Docket Number:	15-RETI-02
Project Title:	Renewable Energy Transmission Initiative 2.0
TN #:	211286
Document Title:	Nancy Rader Comments: Comments Following the April 18, 2016, RETI 2.0 Plenary Group Meeting
Description:	N/A
Filer:	System
Organization:	Cal WEA
Submitter Role:	Public
Submission Date:	4/28/2016 4:56:46 PM
Docketed Date:	4/28/2016

RE: Docket No. 15-RETI-02 -- Comments of the California Wind Energy Association following the April 18, 2016, Renewable Energy Transmission Initiative 2.0 Plenary Group Meeting

PC-21 Heavily Utilized Paths

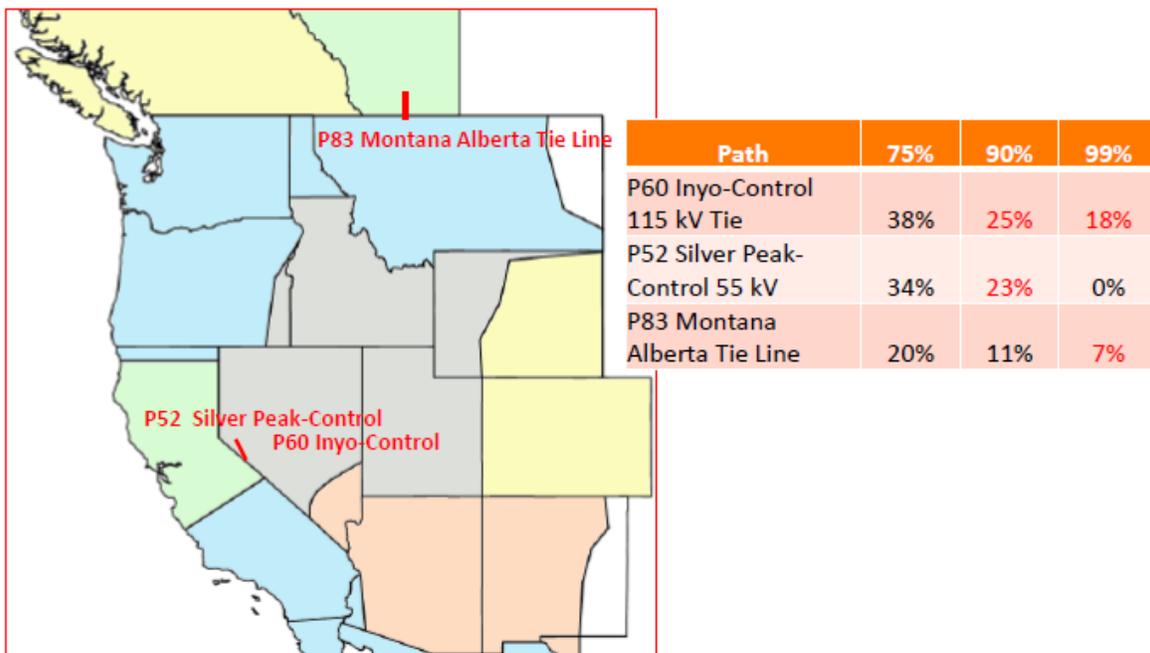
A map and a table accompany the above question on Mr. Turner's slide 9 that are apparently drawn from a WECC reliability study presented at a January RETI 2.0 workshop.¹ The slide shows considerable transmission congestion resulting from a WECC case study called "PC-22: High Renewables." However, another case study – "PC-21: Coal Retirement" -- was conducted by WECC along with PC-22 but was not presented at the January RETI 2.0 workshop.² Very interestingly, PC-21 shows that little or no congestion occurs with coal-plant retirements and significant renewable energy additions across the WECC footprint. (See PC-21 slide reproduced below.) Specifically, the following can be gleaned from PC-21:³

- The retirement of over 6,000 MW of coal units that are already scheduled to occur by 2024 will enable approximately 3,500 MW of wind energy and 1,800 MW of solar to be accessed through dynamic transfer (DT) arrangements with the CAISO (or via an expanded CAISO) without any transmission upgrades.⁴
- The retirement of 16,000 MW of coal capacity (about half that now operating) would enable 9,600 MW of wind and 4,800 MW of solar to be dynamically scheduled with very modest transmission upgrades.⁵

⁴ This result can be inferred by scaling down the assumed 16,626 MW of coal retirements in PC-21 by the amount of announced coal retirements (which total 6,157 MW by 2024). Because congestion was found to be very limited under PC-21 assumptions, it is reasonable to assume that scaling down the assumptions by 63% would produce no congestion. This transmission capacity can be utilized for the purpose dynamic scheduling resources into the CAISO.

⁵ Slide 11 from the October 2015 WECC presentation shows that just three transmission paths become constrained under PC-21; CalWEA believes these paths can be relatively easily and cheaply upgraded.
